SUBJECT: MINUTES OF CRGR MEETING NUMBER 269

Attachment 3 to the Minutes of the CRGR Meeting No. 269
Proposed Final regulatory Guide - DG-1023
"Evaluation of Reactor Pressure Vessels with
Charpy Upper-Shelf Energy Less Than 50 ft-lb"

STAFF RESPONSE TO PUBLIC COMMENTS ON DG-1023

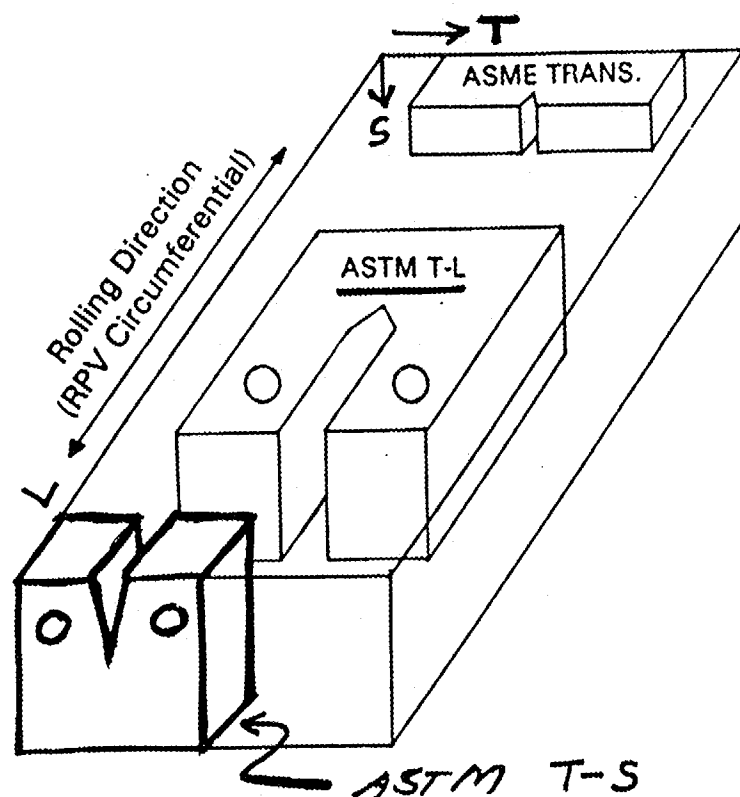
Comment 3: Gery M. Wilkowski, Battelle Memorial Institute, Columbus, Ohio, dated December 12, 1993.

- ASME Appendix-K specifies to use "J-R curve with the proper combination of crack orientation, temperature and fluence level".
- *actual* direction of concern for crack growth
 - L-S direction for axial surface cracks, and
 - T-S direction for circumferential surface cracks.

Staff Response:

- L-T and T-L orientations have been conservatively used for fracture toughness properties in RPVs.
- Staff believes such conservatism is warranted for toughness properties selection

Comparison of pressure-temperature curves for
ASME Section III, Appendix G, cleavage fracture analysis and
DG-1023 low upper-shelf ductile tearing analysis

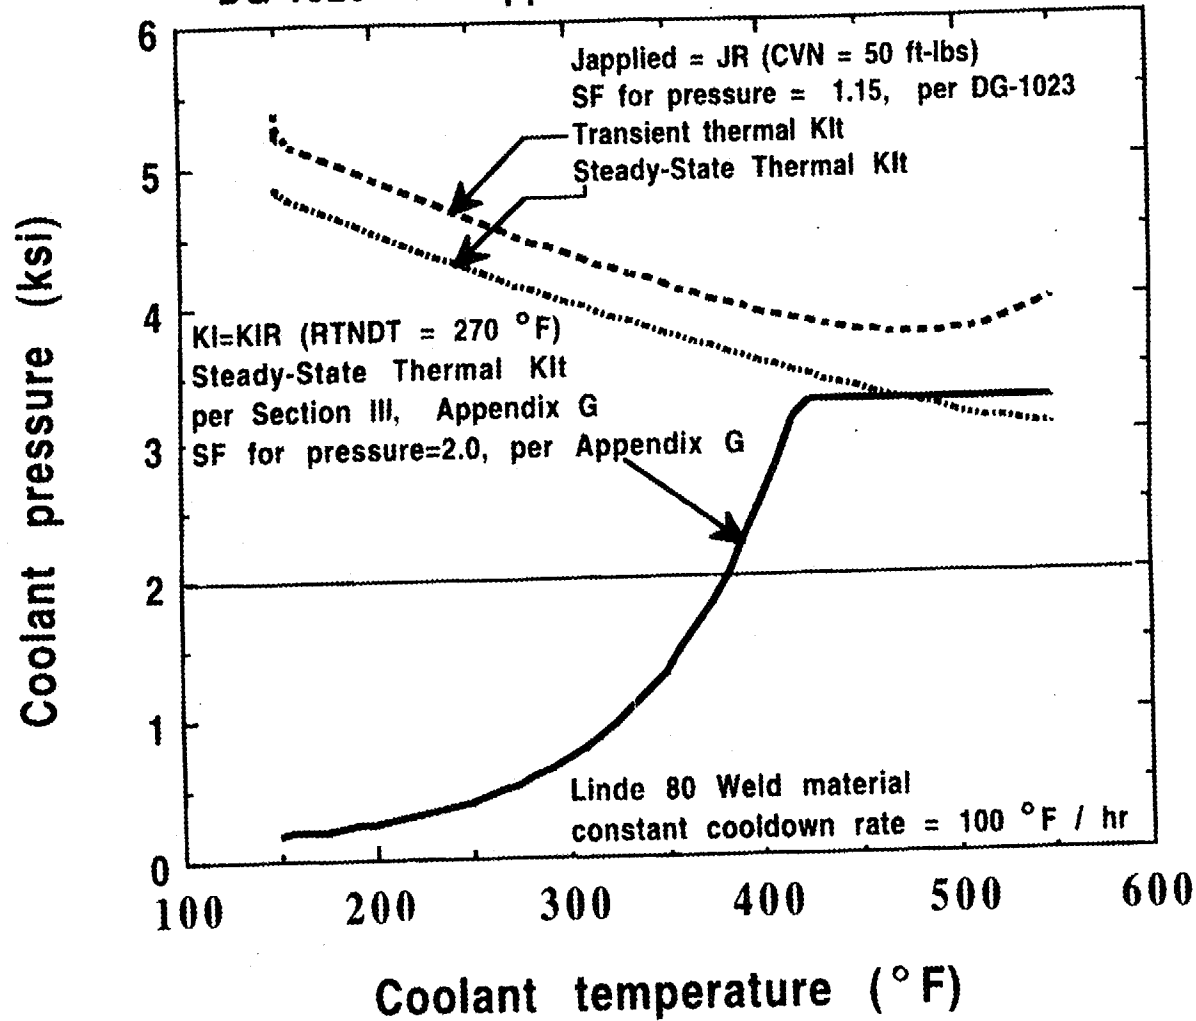
ACRS COMMENTS (12/20/94)

- Recommended publication of the final regulatory guide
- The "combined" safety margins in the reg. guide to be not overly conservative -- with respect to the margins in Appendix-G to Section III of the ASME Code

Staff Response:

- Demonstrated an equivalence in safety margins for the guide, to generate a P-T curve, per Section-III of ASME Code, using
 - * Limiting irradiation condition -- at PTS Screening Criteria ($RT_{NDT} = 270^{\circ}\text{F}$)
 - * Maximum Service Levels A&B cooldown rate -- $100^{\circ}\text{F}/\text{hour}$
 - * Limiting Charpy upper-shelf energy -- 50 ft-lb
- Figure shows that in the "upper" transition-region, the Section III and the LUSE reg. guide methods provide equivalent P-T curve values
